Replacement of the Fisher™ LCP100 with the LCP200 Local Control Panel without Fault Light Option

Fisher™ LCP200 Local Control Panel
without fault light option

Figure 1: Dimensional Differences Between the LCP100 and LCP200 Local Control Panels

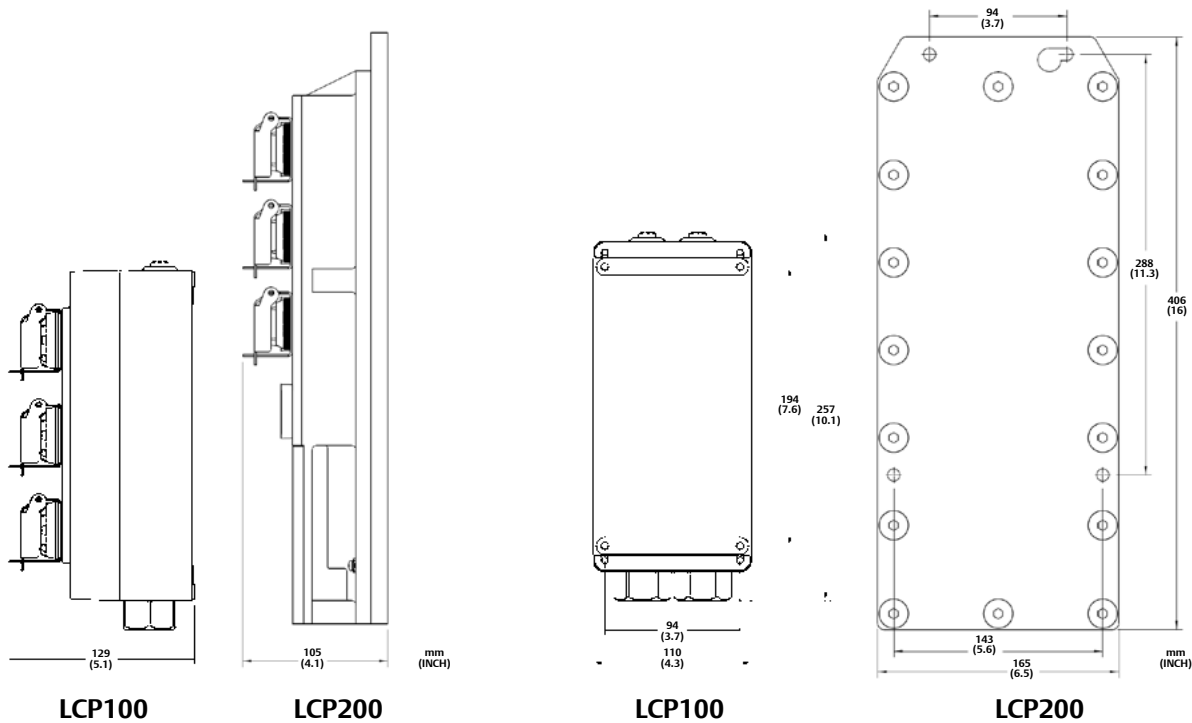
Take note of the dimensional and weight differences between the LCP100 and the LCP200 devices. The LCP200 device is about five times heavier than the LCP100 device, due to its explosion-proof stainless-steel enclosure. The dimensional differences are shown in Figure 1.

Figure 2: Mounting Kit for the LCP200 Local Control Panel

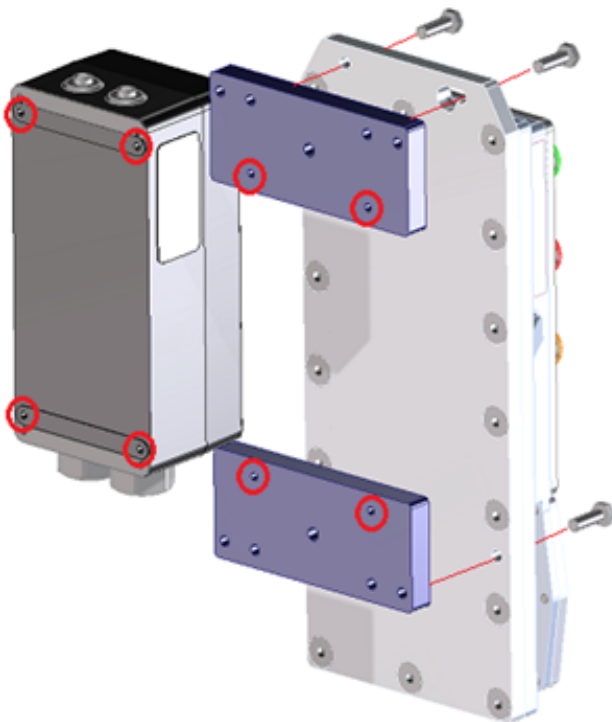
An adapter kit is available to mount the LCP200 device using the mounting holes of the LCP100 panel, as shown in Figure 2.

Figure 4: LCP100 and LCP200 Hardware Comparison

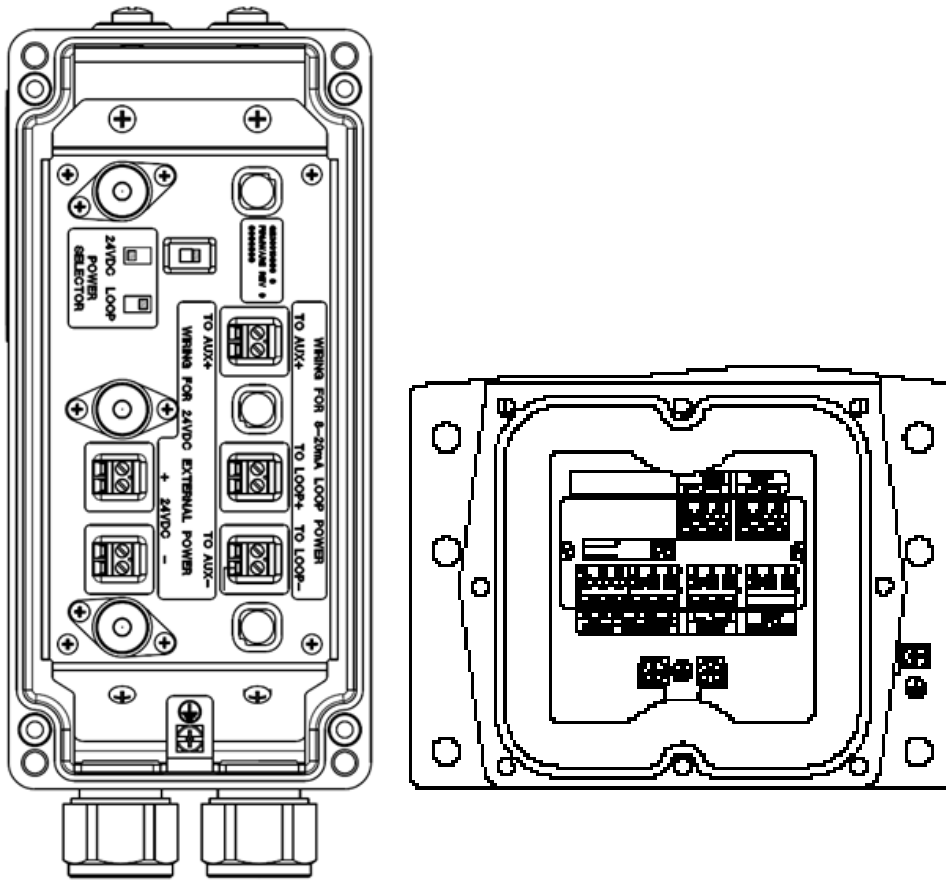
The LCP200 has a dedicated terminal box for making the terminal connections. Unlike the LCP100, the LCP200 does not have redundant terminals. A junction box may be required.

The LCP200 auto detects if 24V power is being applied and so there is no switch to be turned on when using Loop or 24V power.

The LCP200 has a NO – NC relay for the Trip and Reset buttons as well as a test relay for when the diagnostic is in progress. These relay contacts change state when the respective button is pressed or diagnostic is in progress.

Figure 5: LCP200 Local Control Panel Warning

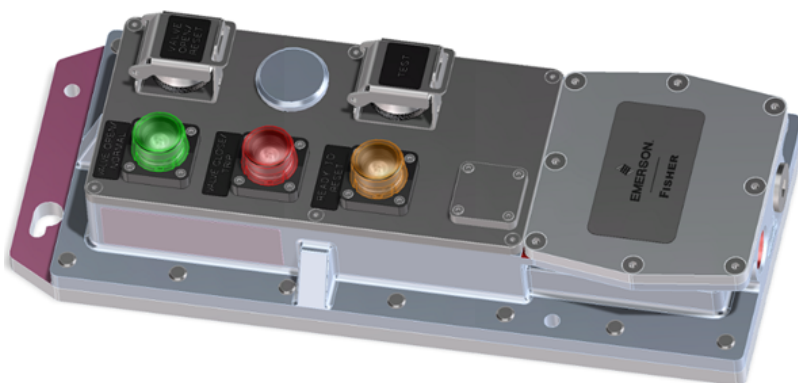
Do not take powerful magnets near the LCP200 control panel.
